**REVIEW OF THE UNSATURATED ZONE
MODELS USED TO SUPPORT THE VIABILITY
ASSESSMENT OF A REPOSITORY AT
YUCCA MOUNTAIN**

**Nuclear Regulatory Commission
Contract NRC-02-97-009**

**Center for Nuclear Waste Regulatory Analyses
San Antonio, Texas**

February 1999

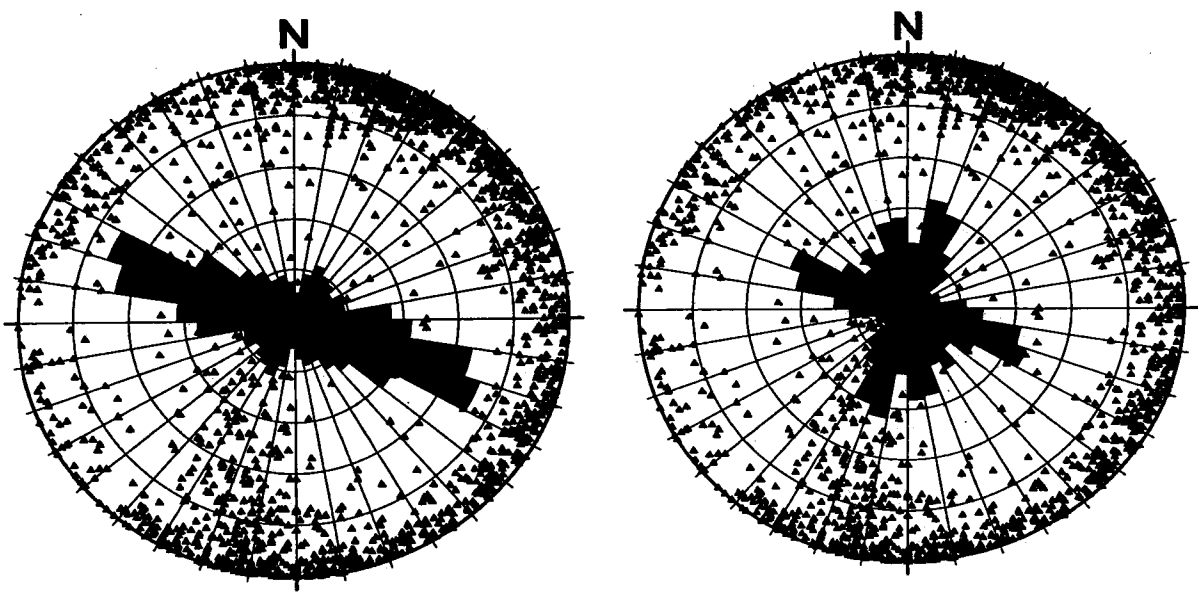
The TSPA-VA approach to bounding the reasonable range for α_f could be improved in two ways. First, the value assigned to α_f should be based on the largest aperture sizes, not on the mean or effective size. Using the largest fracture apertures as a basis for estimating α_f would result in higher values; this would result in less capillary suction in the fracture continuum, and thereby, in lower fracture saturation. Second, the ESF fracture frequency data used to estimate α_f should be corrected to account for the under-representation of fractures that intersect the ESF at low angles. Figure 2-1 illustrates a rather dramatic difference in the characterization of fracture data from a 500-m section of the ESF—between stations 30+00 and 35+00—after applying the Terzaghi (1965) correction method. It can be seen that correction results in an increase in the estimated fracture frequency from 4 m^{-1} to 6.6 m^{-1} . Increased fracture frequency would result in calculation of lower effective fracture apertures and hence, lower values of α_f . Lower values of α_f result in predictions of greater fracture saturations. Although these two shortcomings in estimation of α_f tend to have offsetting effects on predicted fracture saturations, it is not clear if either would have a dominant effect. Therefore, increased confidence in estimates of α_f could be gained by adopting these two improvements.

- The values assigned to fracture continuum hydraulic properties, α_f and m_f , in the TSPA-VA parameter sets are not justified by the distribution of fracture apertures observed on the model-grid scale. Additionally, the calculated range of α_f values considered in the TSPA -VA analyses may be biased because ESF line surveys of fracture frequency have not been corrected to account for the underrepresentation of fractures that intersect the ESF at low angles. Underestimation of fracture frequency results in overestimation of effective fracture apertures which, in turn, results in overestimation of α_f .

- DOE should continue with plans to perform 3D model calibrations.
- It should be demonstrated that values assigned to fracture continuum hydraulic properties, α_f and m_f , are consistent with the distribution of fracture aperture sizes. Additionally, fracture data used in such a demonstration should be corrected to account for the under-representation of fractures that intersect the ESF at low angles.

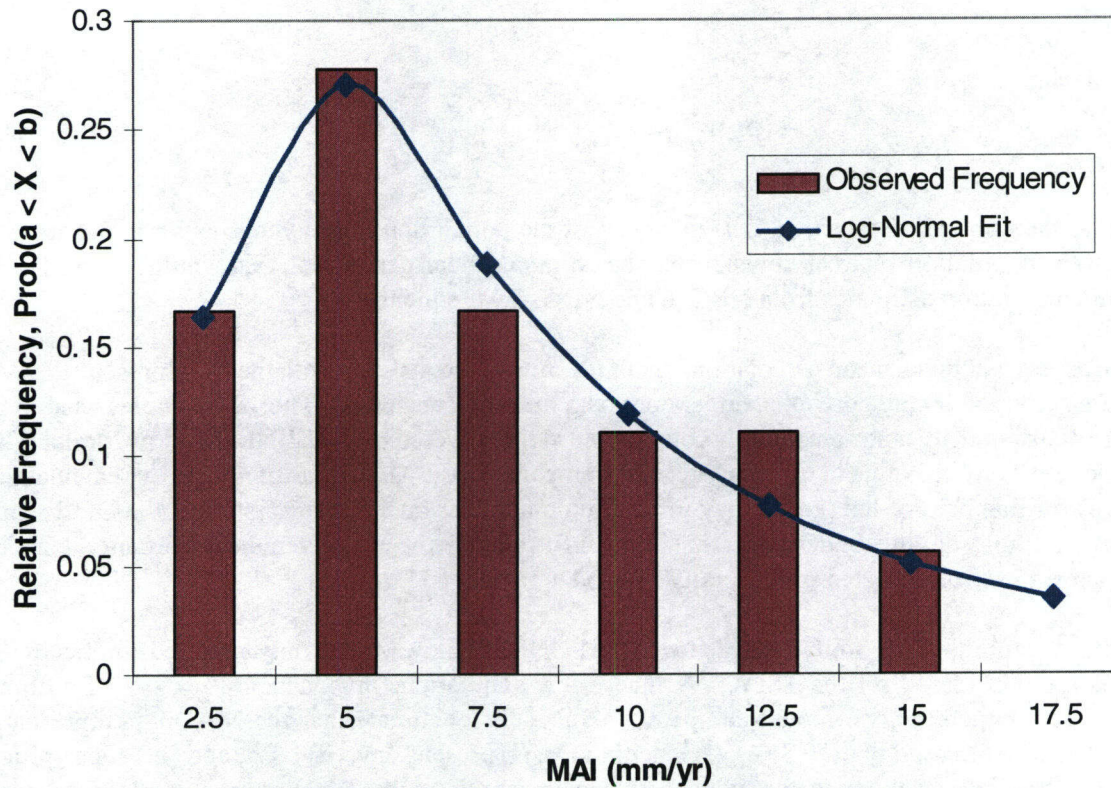
Figure 3-1 shows that the relative frequency of MAI estimates based on data from the included boreholes is fit well by a log-normal distribution with a \log_{10} (MAI) mean value of 0.76 and a standard

where m_y is the population mean, $m_{\log y}$ is the mean of the population \log_{10} values, and σ is the standard deviation of the population. One can envision that the estimated mean percolation flux would be significantly higher if the infiltration estimates from NRG-6 and NRG-7 were included.

To assess whether a mean percolation flux of 6.7 mm/yr is consistent with the DOE present-day MAI map, the area covered by the borehole temperature data must be considered. The 18 boreholes used in this analysis are distributed over an area roughly comparable to that covered by the LBNL UZ Flow Model. Thus, the mean percolation flux value of 6.7 mm/yr can be compared to the MAI value of 4.9 mm/yr calculated by DOE (1998) for that area of the present-day infiltration map. This analysis suggests that the DOE map of present-day MAI may slightly underestimate shallow infiltration. However, given the uncertainty in making such estimates, the two estimates are generally in good agreement.

- The authors agree that the use of MAI multipliers, used to incorporate uncertainty in MAI estimates into the TSPA abstraction, is reasonable. However, the methodology for calculating the probabilities assigned to MAI multipliers is biased toward producing low values for MAI.

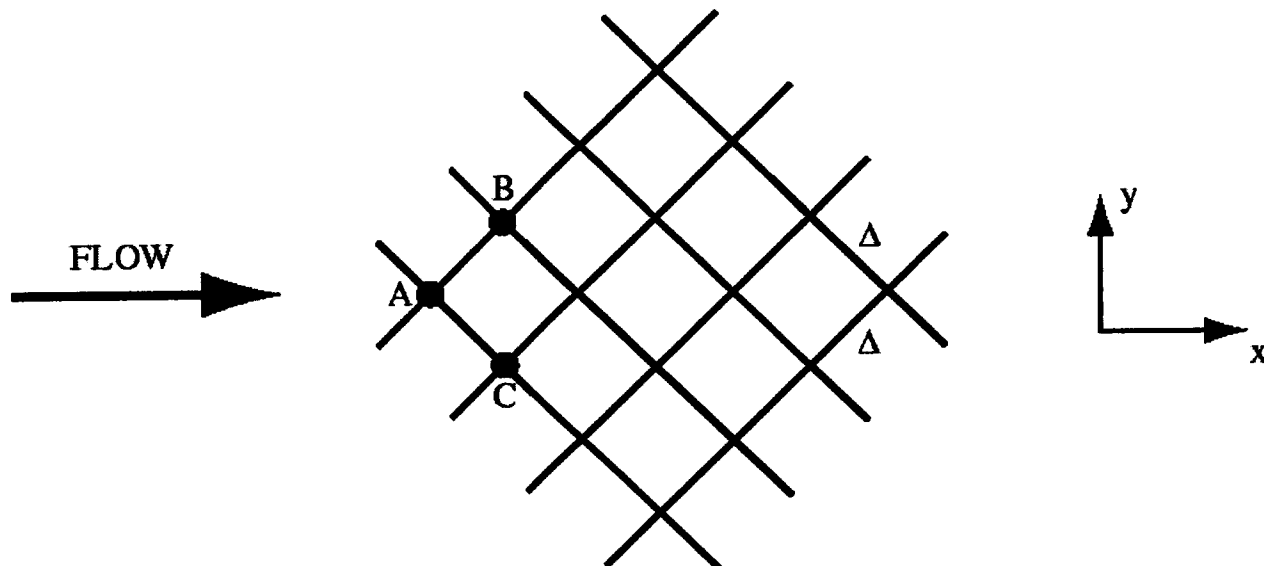
The RTTF method creates artificial numerical dispersion whenever the node connections are not aligned with the principle direction of flow. For example, consider a grid aligned 45° to the flow field, as shown in figure 5-1, where nodal connections are used rather than cell faces. A particle released at point A has a 50 percent probability of going to point B and a 50 percent probability of going to point C with the movement along the y-axis being $\pm\Delta/\sqrt{2}$, where Δ is the distance between nodal connections. The variance in position along the y-axis after one step is $(\Delta^2/2)$. After n steps (where $n \gg 1$), the Central Limit Theorem implies the distribution along the y-axis should be approximately normal with a variance of $n(\Delta^2/2)$. By definition (Bear, 1972), the transverse dispersion is

The mesh in figure 5-1 is similar to the mesh used for horizontal layers in the repository footprint. A higher coordination number may reduce dispersion, however, alignment of node connections will not always coincide with the flow field below the repository, regardless of the coordination number.

- Validation of the RTTF method is needed before results can be accepted with reasonable confidence. The method is ideal for advection dominated transport through the fracture continua, but flow and transport through the matrix of nonwelded units are considered the primary natural barrier in the UZ below the repository. The issue of artificial numerical dispersion in the RTTF model will become more important as focused releases over the first 10,000-yr period are given increased emphasis in PA.
- The consequences of decoupling matrix diffusion from matrix advection in the RTTF approach are not well understood and may result in overestimation of matrix retention processes.

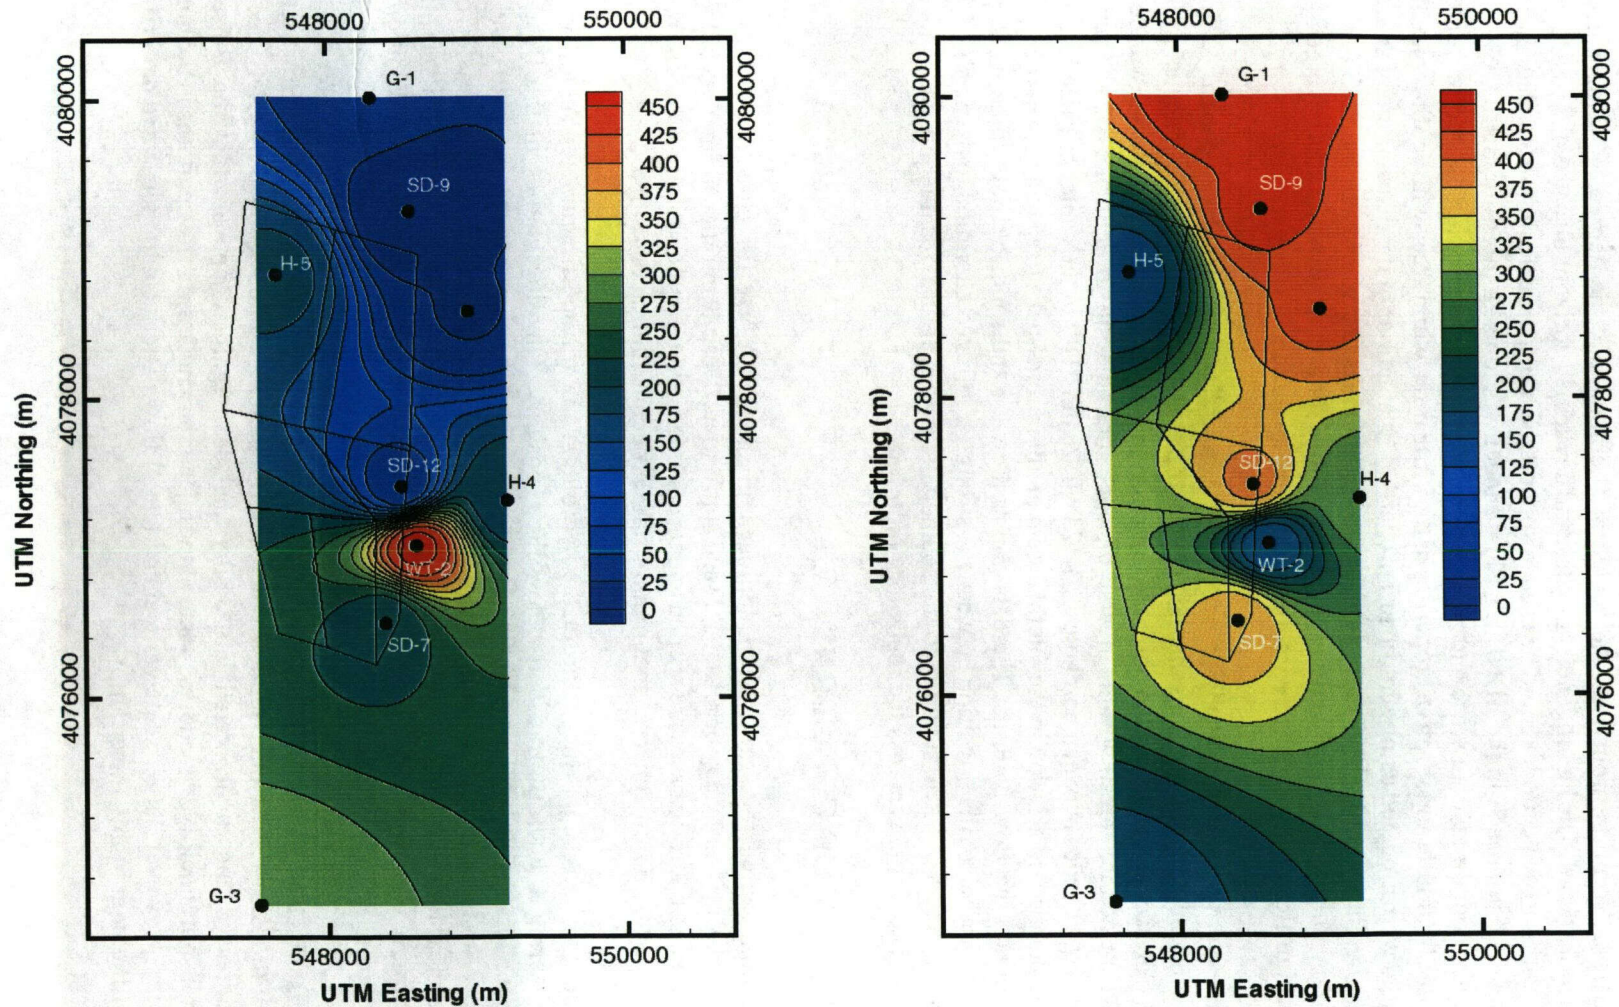
nonwelded subunits by Carey et al. (1997), would be useful for assigning hydrologic properties. However, additional measurements of UZ hydrologic properties are needed. In particular, the relationships between hydraulic properties, sorption properties, the degree of alteration, and the degree of welding need to be investigated in more detail. The heterogeneity of vitric and devitrified horizons also needs further evaluation. Results of this transport scale model could be used to support the transport calculations made using the site-scale UZ model. The approach in the LBNL UZ Flow Model was to use a threshold of 10 wt % zeolite in each of four layers containing both vitric and zeolitic nonwelded tuffs. Areas with less zeolite content were modeled using the hydraulic and sorptive properties of the vitric tuffs, while areas with zeolite content greater than the threshold were modeled using zeolitic tuff properties. Evaluations of the distribution of zeolites have been conducted by Carey et al. (1997) using larger threshold values (20 wt %) and by NRC (1998) using smaller threshold values (2.5 wt %). Results of these evaluations show that the model area covered by zeolitic layers changes significantly when different threshold values are used.

Another approach, more in line with the NRC TPA model, would be to develop maps of composite thicknesses of vitric and zeolitic horizons that lie between the repository and the water table, using such data as compiled in Carey et al. (1997) and in borehole log information. For example, figure 5-2 was developed using a 10 percent zeolite threshold and inverse distance interpolation to delineate vitric from zeolitic horizons. The sharp changes between boreholes SD-12, WT-2, and SD-7 in the center of each figure may be indicative of the pattern of variation in the lateral extent of alteration. Such sharp changes in rock properties could locally impact the flow patterns. The data gap to the west and south of these three wells prevents adequate characterization of the transition between the strongly zeolitized alteration to the north Calico Hills subunits and the nonaltered vitric subunits to the south. Note that in figure 5-2, the presence of vitric and zeolitic subunits is continuous across the repository footprint.
